Legal Description of Dredged Material Management Area DU-9

RE: DU-9 Dredged Material Management Area
 Application No: 0129250-001-EI (formerly File No. 552962379)

This letter is in response to your December 8, 1999, request for additional information (RAI) for the above referenced Environmental Resource Permit application for the DU-9 Dredged Material Management Area. The revised mitigation plan (Attachment A) and associated figures contain all revisions requested in the referenced RAI. For your convenience, this revised plan replaces our previous submittal in its entirety.

**MITIGATION PROPOSAL FOR DREDGED MATERIAL MANAGEMENT AREA DU-9
ST. JOHN'S COUNTY, FLORIDA**

Figure 3
Plan View
of DU-9 Mitigation Area

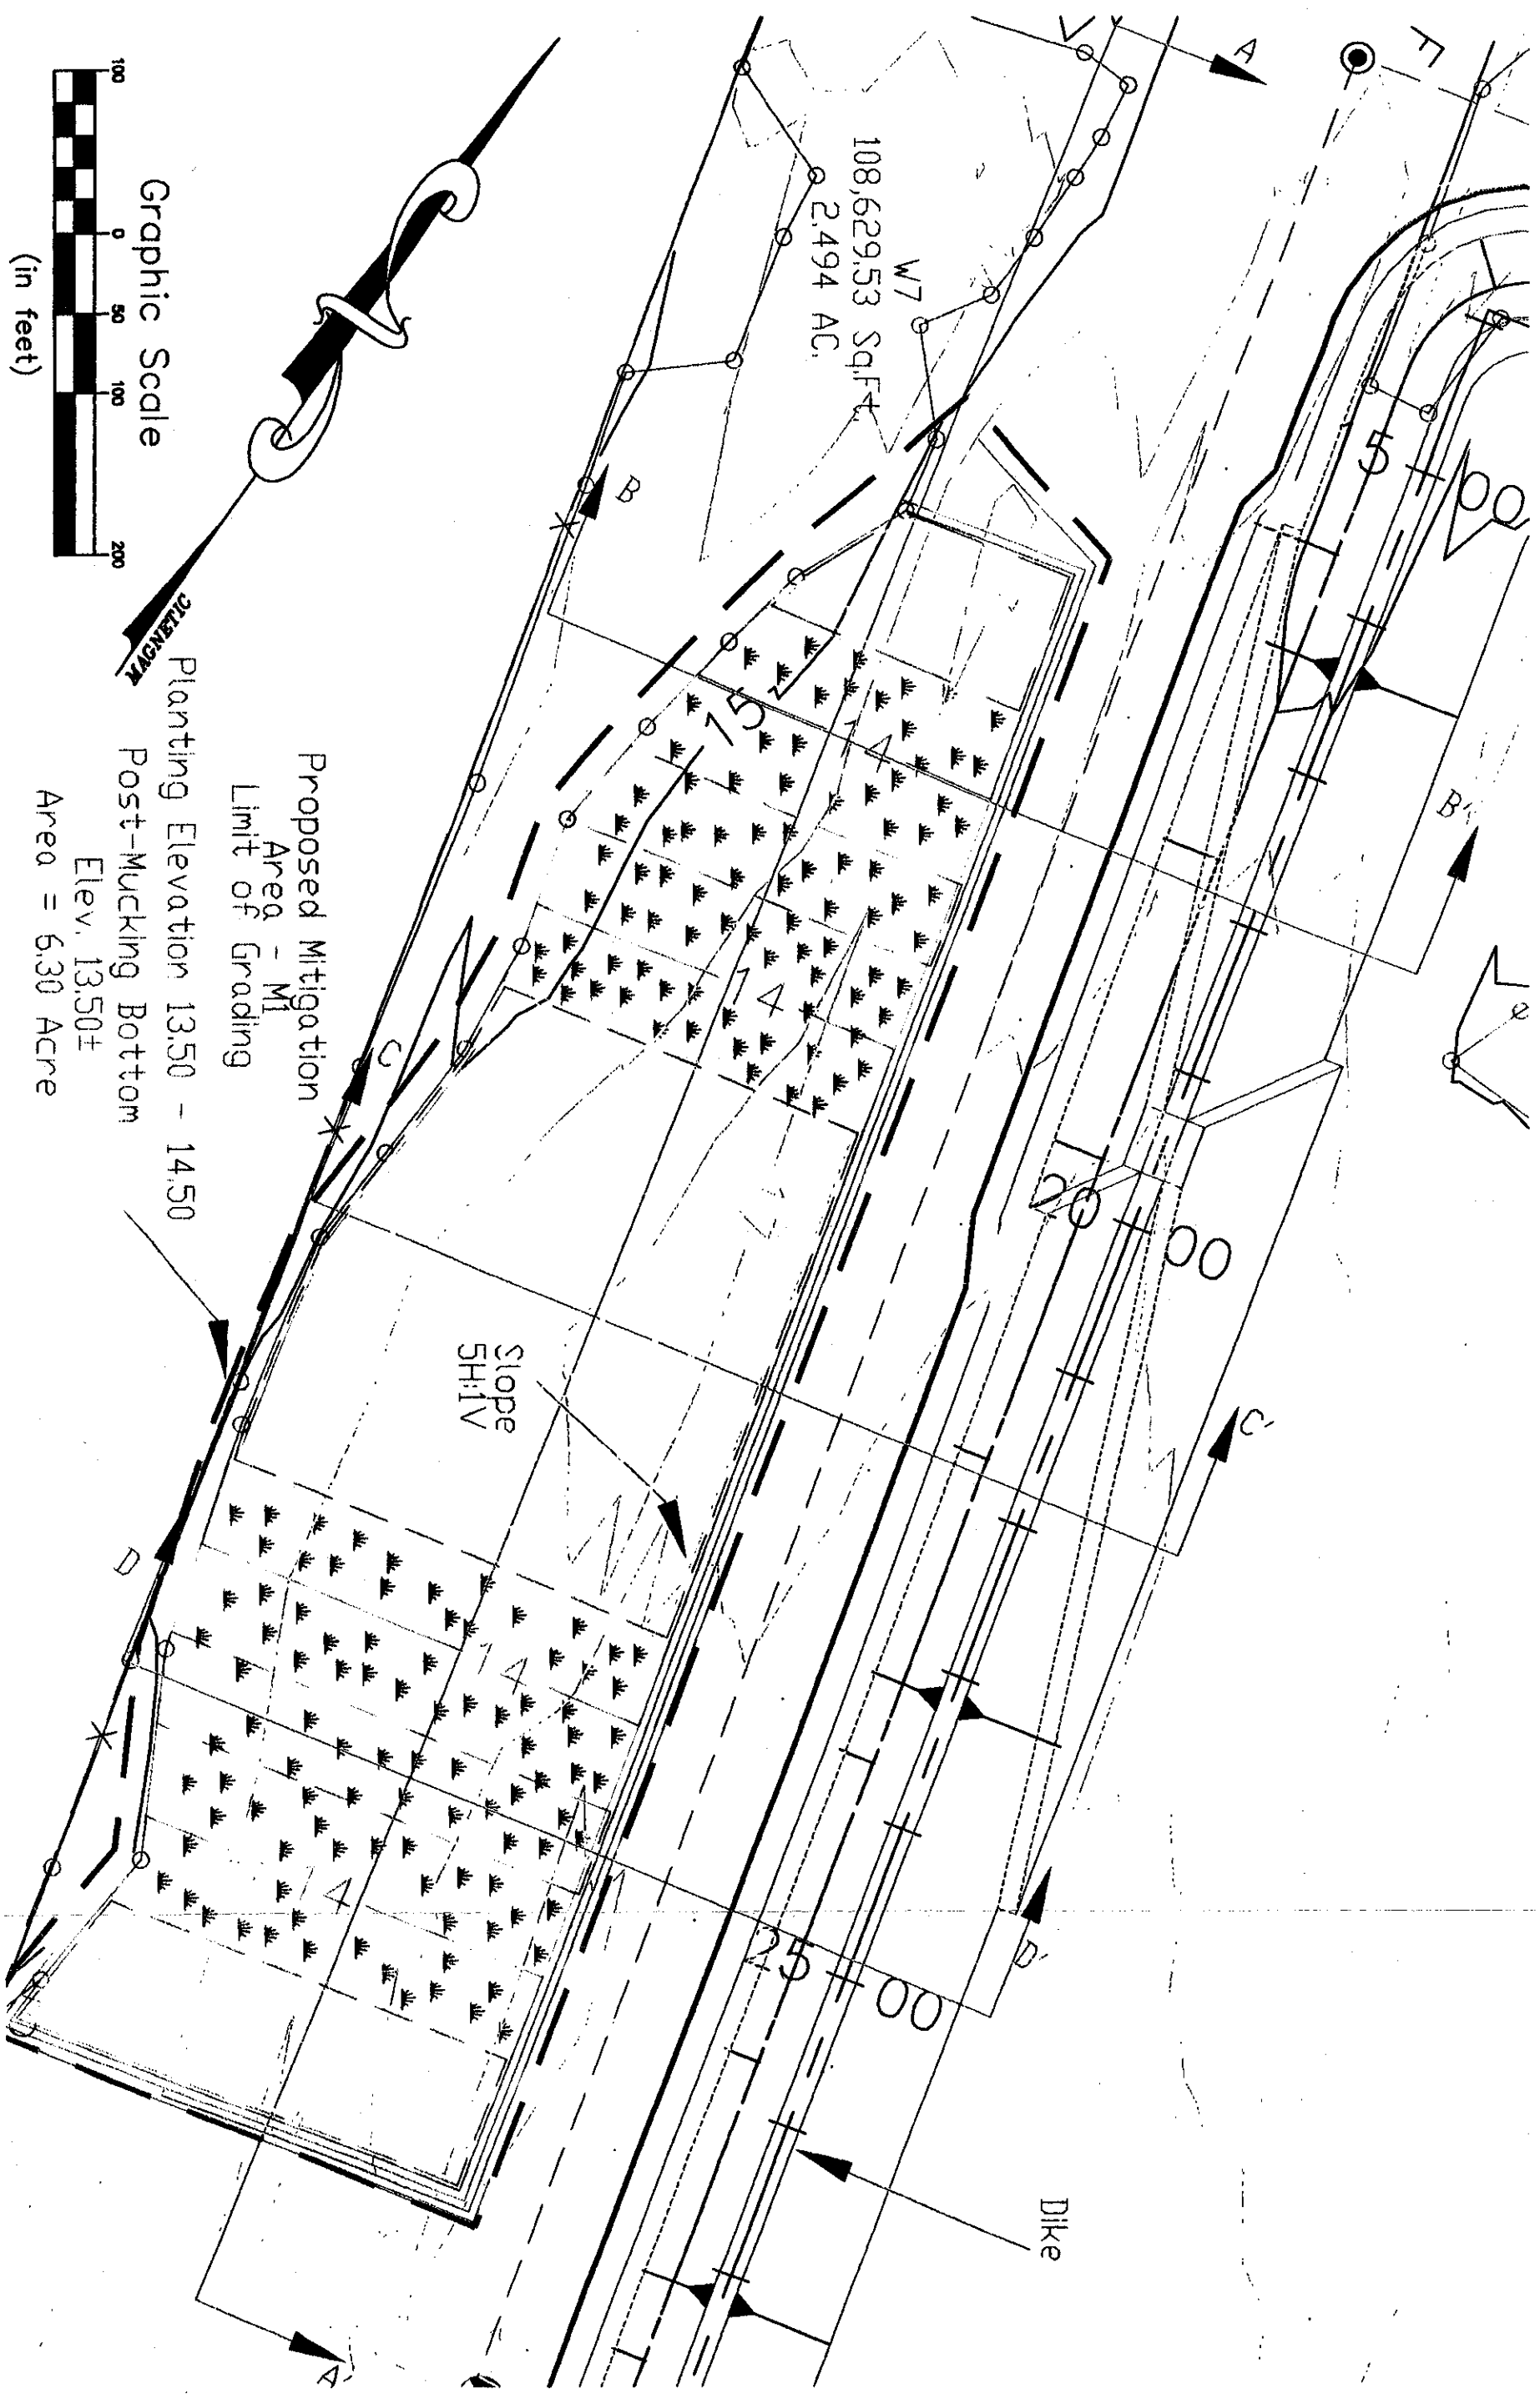
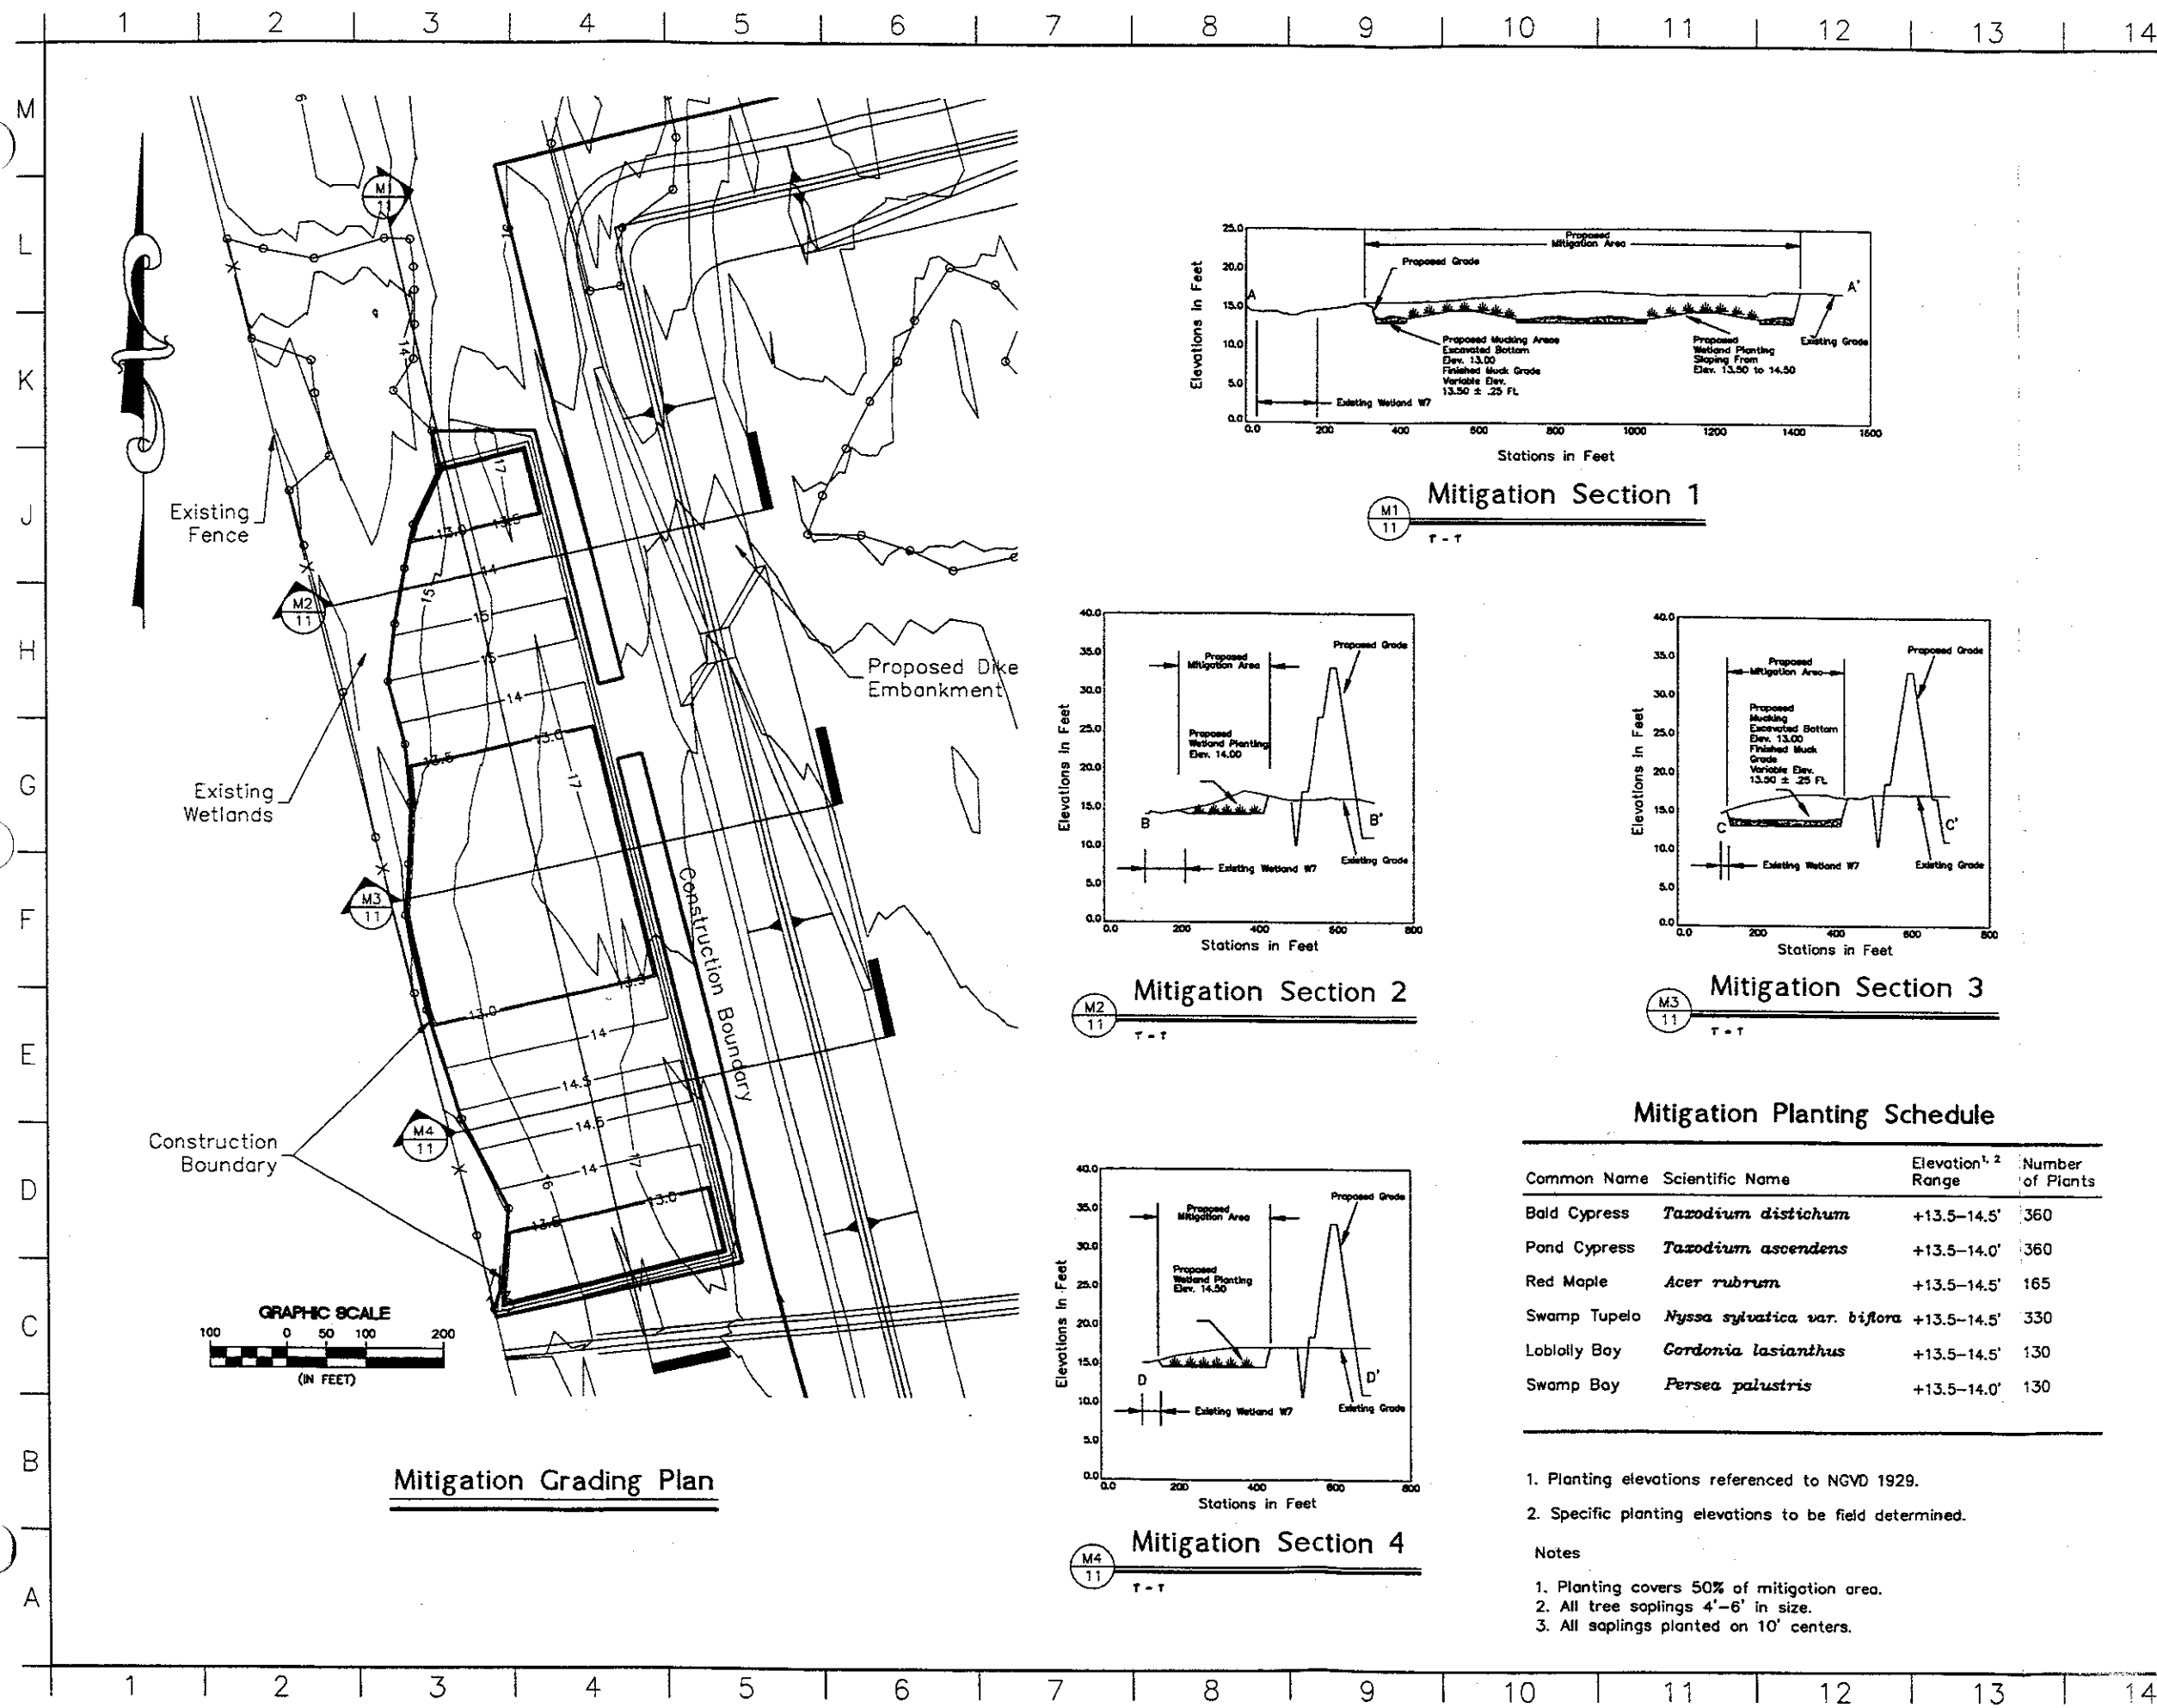
Item 9. Please provide scaled plan view and cross-sectional drawings showing the existing grades in the mitigation site and proposed final elevations (including mucking). The plan view drawing should depict the grades in one-foot contours and both should reference ordinary low water and ordinary high water on-site. We will need drawings that can be easily copied (no light colors) or provide multiple copies for distribution.

Response: See Attachment A, Figures 3 – 4.

The mitigation area will be excavated to a depth of +13.0 ft NGVD in the unplanted areas and +13.5 ft to +14.5 ft NGVD in the planted areas. Final elevations including mucking in the unplanted areas will be about +13.5 ft NGVD. Final elevations in the planted areas will range from +13.5 ft to +14.5 ft NGVD.

Fig. 4

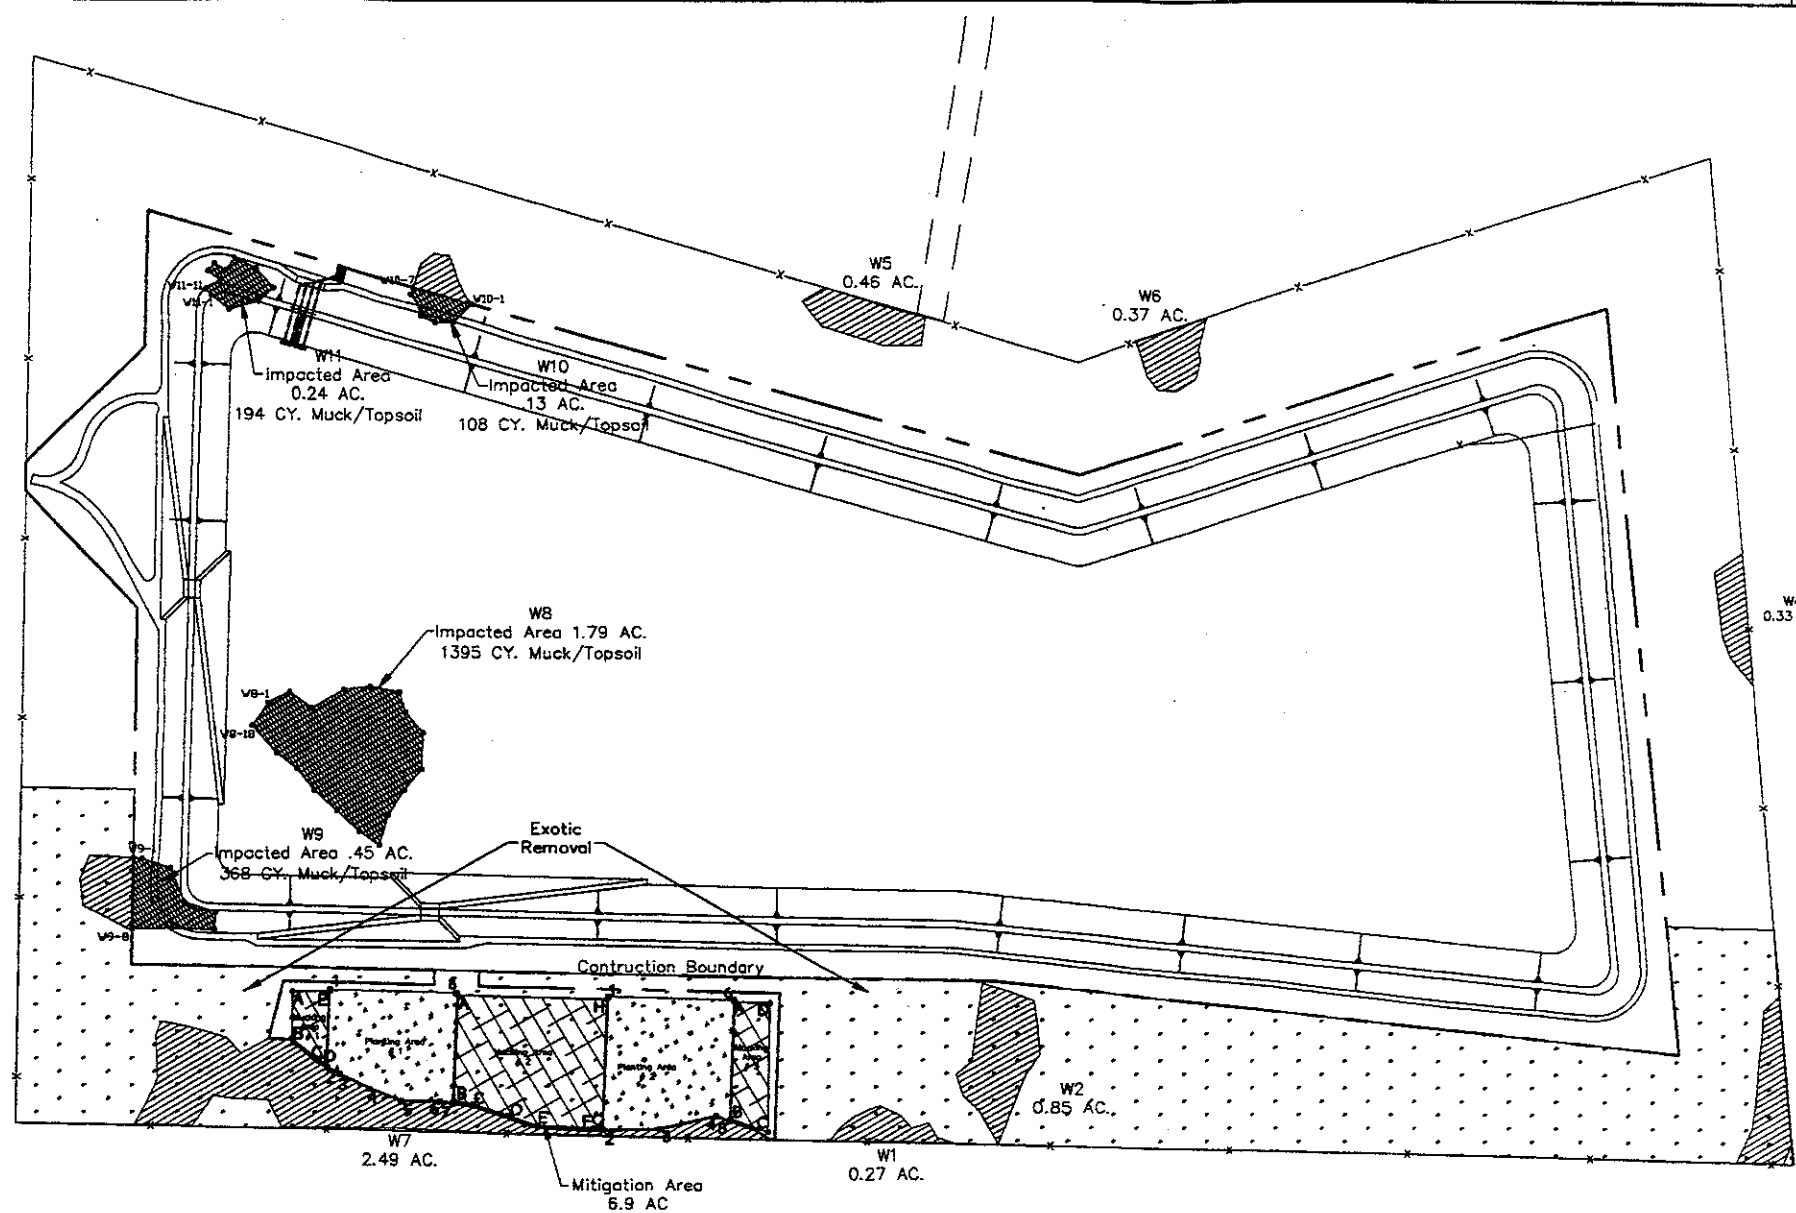
- Item 11. *Please describe long-term management plans for maintaining the mitigation wetlands. Please indicate on the plan view map the area to be maintained free of exotics (at a minimum, the western half of the site in the remaining buffer zone).*

During construction of the mitigation area, exotic vegetation, primarily Chinese tallow (*Sapium sebiferum*), will be removed from the area west of the western containment basin construction boundary and extending north and south to the site boundary and east to about 150 ft beyond existing wetlands (see Figure 4). The vegetation removal will reduce exotic seed stock and minimize exotic recruitment in the mitigation area. During annual site inspections, the need for further exotic removal will be determined. If necessary following inspections, exotic vegetation will be removed by hand clearing and herbicide treatment. As noted in our November 18, 1999 submittal, the FIND will revise the DU-9 site management plan to include long-term mitigation area maintenance.
